Subject: DA 2021/2383 - 4 BANGALOW AVENUE MONA VALE

DA 2021/2383 - Alterations and additions to residential development - Alterations and additions to a dwelling house

# **4 BANGALOW AVENUE MONA VALE**

EXTRACT FROM SUBMITTED PLANS SHOWING SUBSTANTIAL CHANGES TO THE APPEARANCE OF THE ON-SITE STRUCTURES

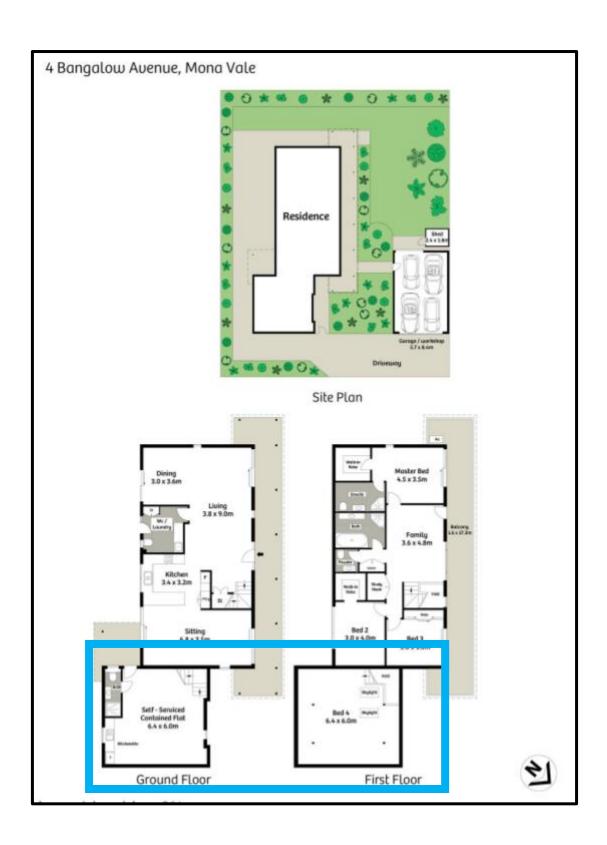
The proposal as evidenced in the following extracts from the submitted plans clearly indicates the significant extent of change of appearance that will occur as a consequence of the proposed works.

The streetscape of this part of Bangalow Avenue will be significantly altered as evidenced in the earlier extract from the submitted plans.

Again, referring to the earlier extract from the submitted plans, it is readily evident that the outlook from within the existing building will be substantially altered by the deletion of an upper level balcony and its replacement with additional floor area and the provision of two gable ended roof structures thereby entirely changing the outlook from within the existing building.

It is readily evident that the proposed demolition and replacement structure will result in an entire change in the characteristics of the form of the existing structure.
